UNITED STATES PATENT AND TRADEMARK OFFICE

10/616,218

Office Action Summary	Application No. 10/616,218	Applicant(s) GOTFRIED, YECHIEL	
	Examiner Michael J. Araj	Art Unit 3733

DETAILED ACTION

Figure 1 ('889)

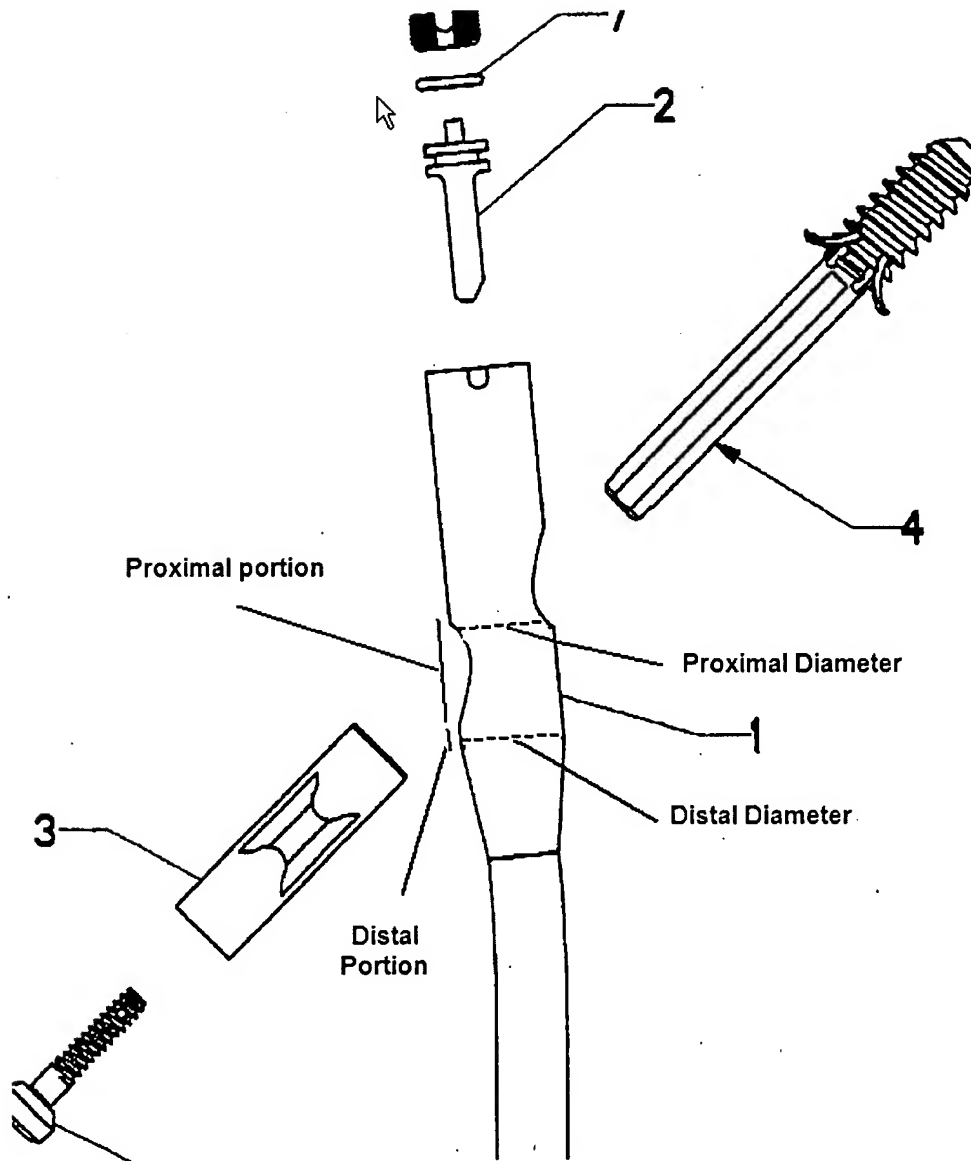
Bramlet et al. disclose an intramedullary nail comprising a proximal head that defines at least one hole therethrough, a sleeve comprising a locking mechanism that is adapted to engage the whole when the sleeve is inserted in the hole and a screw where the sleeve is adapted to slidably receive the screw. The head has a distal portion and a proximal portion where the proximal portion has a diameter less than or equal to about 80% of the distal diameter. (see Figure 1 below) The distal portion defines at least one hole therethrough and comprising a sleeve (3), which comprises a locking mechanism (2). This locking mechanism prevents longitudinal and rotational movement of the sleeve with respect to the nail. Also disclosed is that the intramedullary nail is adapted to be implanted in the bone, such that no portion of the nail extends to an external surface of the bone. It also can be interpreted that the proximal head has a visually discrete distal portion and proximal portion. (See Figure 25) There is also a visual discreteness between the proximal and distal portions with respect to the angled hole for the sleeve. There is a sudden narrowing between the proximal and distal portions (as seen below).

Bramlet et al. disclose the claimed invention except for a locking element with a female coupling element and a depressible male coupling element that is configured to engage the female coupling element so as to prevent the rotational and longitudinal movement between the sleeve and the nail. Viscount et al. discloses the use of a

coupling device with an attachment means that locks two respective pieces together preventing longitudinal and rotational movement. They disclose a male coupling element (21) that locks into place with a female coupling element (6). It would have been obvious to one skilled in the art at the time the invention was made to have created the device of Bramlet et al. with a snap-fit type locking mechanism in view of Viscount et al., in order to have a device that will be secured well upon placement in the body and avoid the risk of other problems that can arise with movable pieces.
